Access Compliance Report

Public Rights-of-Way

| Intersection ID: 3466 | Main Street: ENCHANTMENT_COVE_LN | Cross Street: WOODLAND_COVE_CT | Location: NW |
| ADA ID: 4C5B0DF605CE | Ramp Type: Perp | Initial Pass/Fail: Fail | Overall Compliance: No |

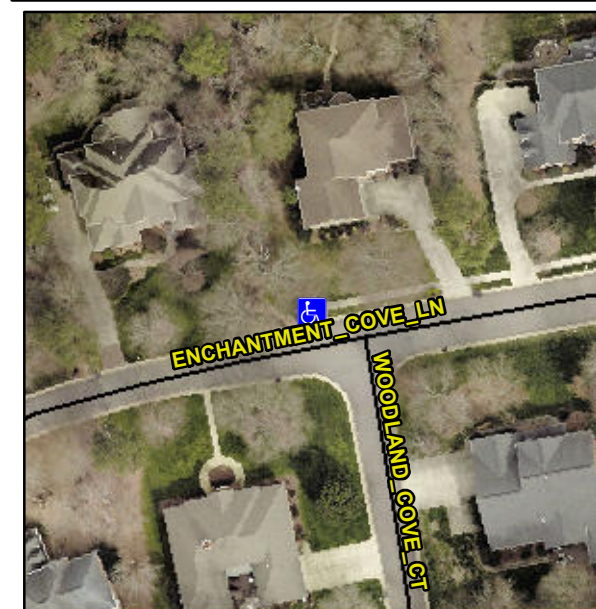
Remove & Replace Entire Ramp.

Not Found, R304.2.2

| Compliance | Description | Data | Compliance | Description | Data |
|------------|-----------------------|------|------------|-----------------------------|------|
| N/A | Ramp Length (in) | 96.0 | No | Ramp Slope (%) | 10.0 |
